Appendix

Small Entity Representative Comments

RE: Comments on New Source Performance Standards and Emissions Guidelines for
Municipal Solid Waste Landfills

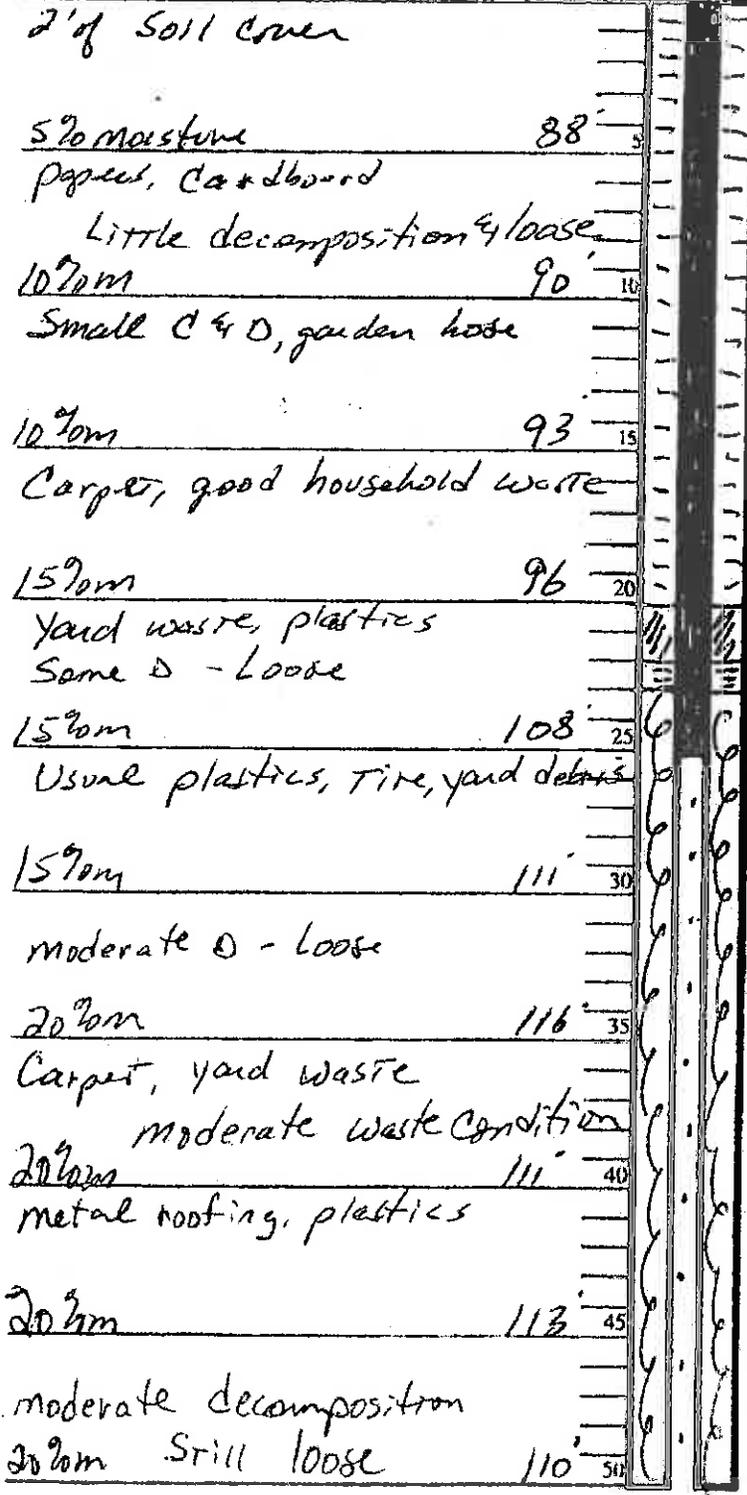
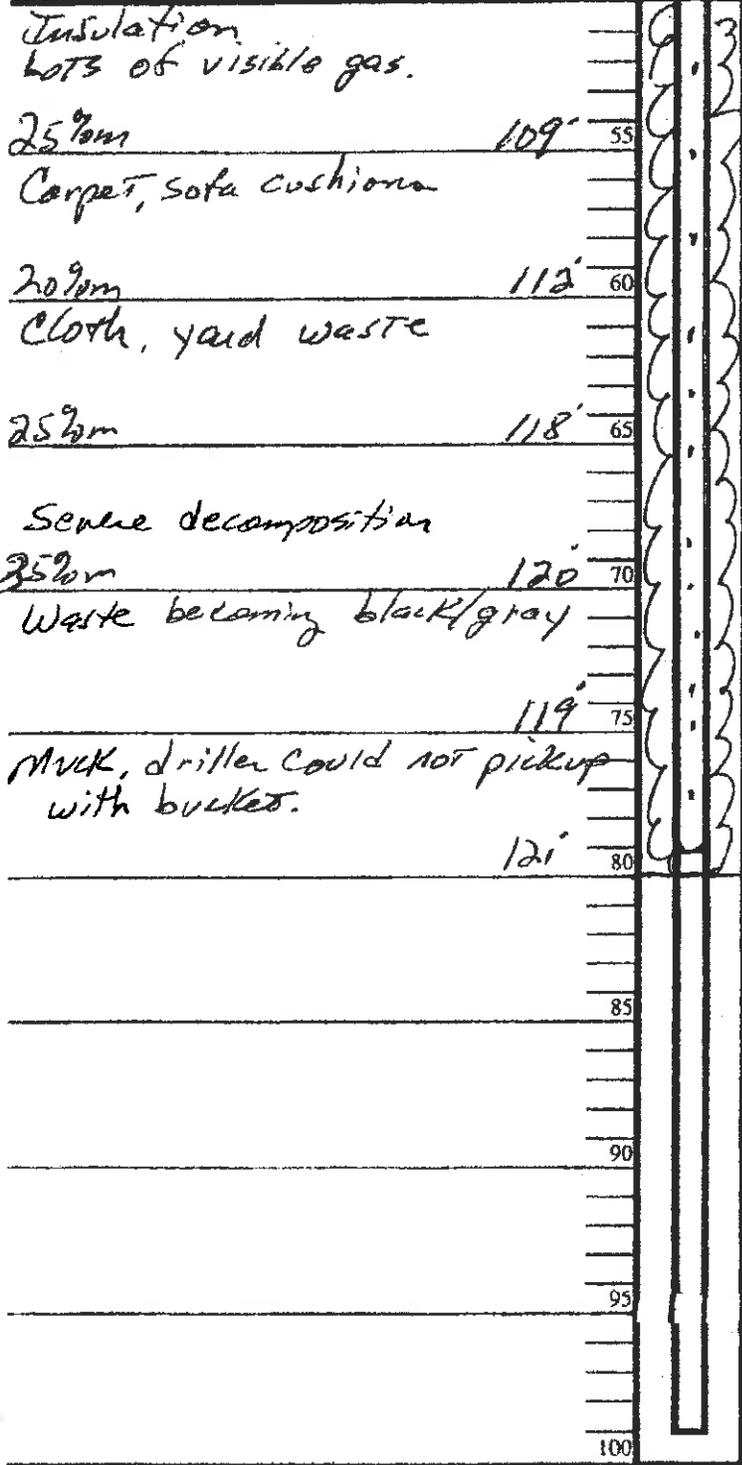
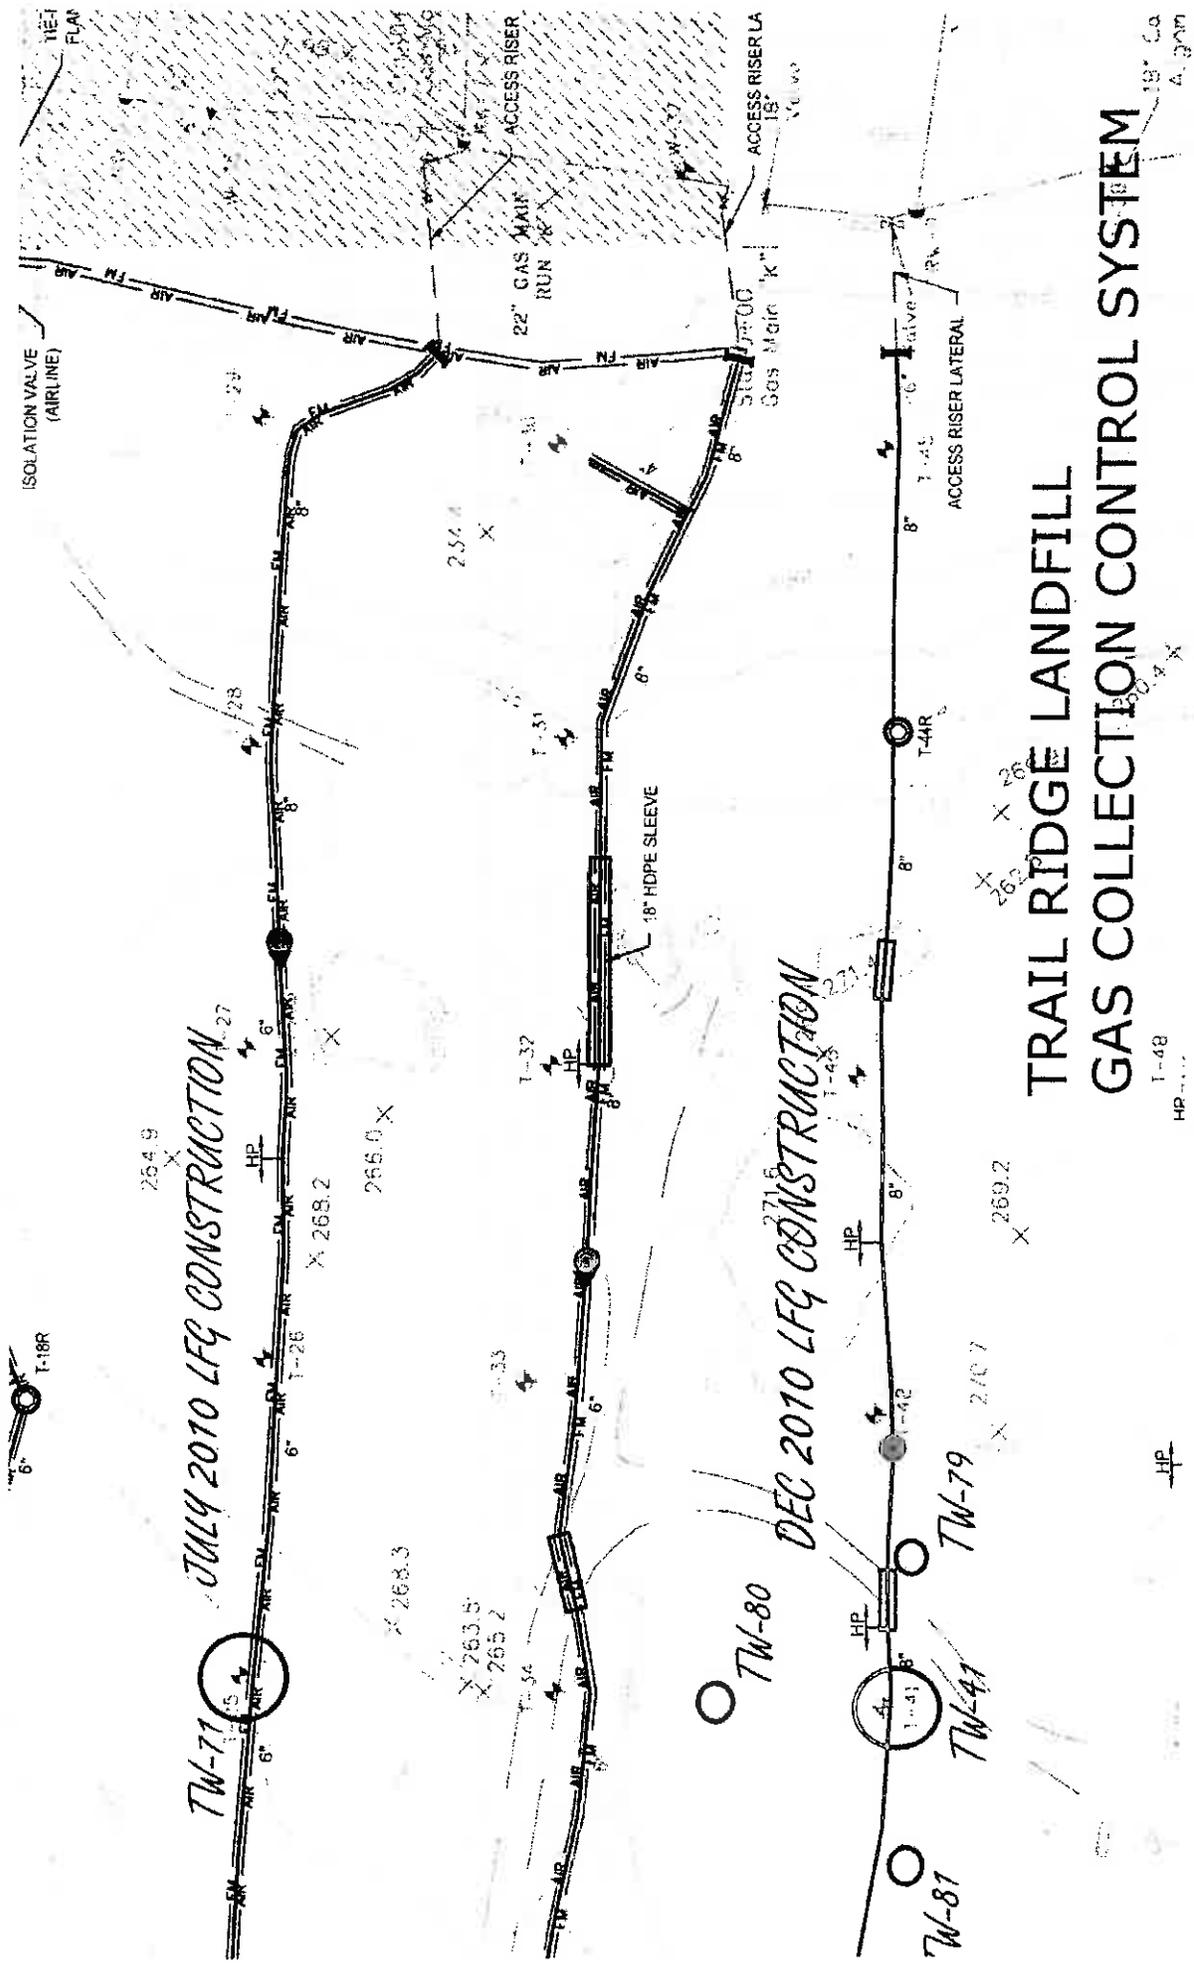
The City of Jacksonville (COJ) is submitting this correspondence to the Florida Department of Environmental Protection (FDEP) to request an alternate operating temperature of 141°F for landfill gas extraction well TW-71 at the Trail Ridge Landfill in Baldwin, Florida. The City requested an alternate temperature limit for this well July 22, 2010 and an alternate timeline to provide additional time to investigate and address elevated temperatures on August 19, 2010. FDEP denied these requests on September 3, 2010 on the basis that the well temperature had temporarily returned to a temperature below 131°F at the time of the July 22, 2010 request. FDEP directed the City to expand the system within 120 days in such instances.

The City has maintained that operational tuning or system expansion is unlikely to correct high temperature wells that are not affected by fire, and that such wells operating near the 131°F limit may naturally fluctuate around the limit over time without any influence of corrective actions or well-field management. We believe this is the case with this well, which has now returned to an operating temperature of 136°F and was clearly not affected by the installation of wells TW-79, TW-80, TW-81 just to the south (see Attachment 1 for well locations). Monitoring data for TW-71 is provided in Table 1 below. The City believes that our actions have proven that there is no operational action or system expansion that will correct this temperature exceedance, and since there is no evidence of fire or adverse impacts to methanogenesis, that a higher operating temperature is warranted and necessary. The City also does not feel it is warranted to request an extension to the 15 or 120 day NSPS timelines for this well, as we again maintain that well-tuning and system expansion are not going to correct the problems. As such, additional time for corrective measures is unlikely to yield any benefits. Natural temperature fluctuations should not be cause to deny the temperature variance or assume the issue has been addressed.
